MANDATORY**SEL-71-10****TITLE**

POWER PLANT - TRANSMITTAL OF CONTINENTAL MOTORS SB18-04A REPLACEMENT OF FLANGED NUT

Supersedes SB18-04
TECHNICAL PORTIONS
FAA APPROVED

SUBJECT: Replacement of Flanged Nut (P/N 652541)
Identified with Manufacturer’s Stamp “ZB”

Figure 2. Flanged Nut, Profiles

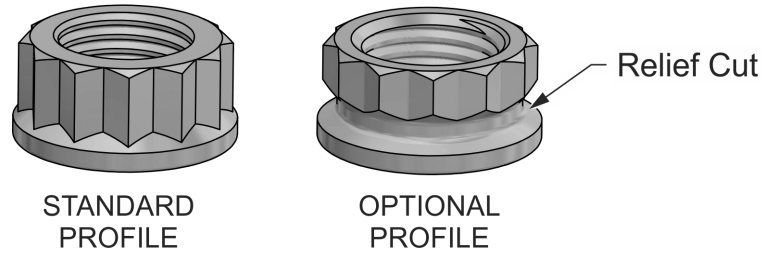
NOTE: Flanged nuts **purchased prior to 1 OCT 2017** or identified with the “OPTIONAL” profile (relief cut, as shown in Figure 2) **do not** require replacement.
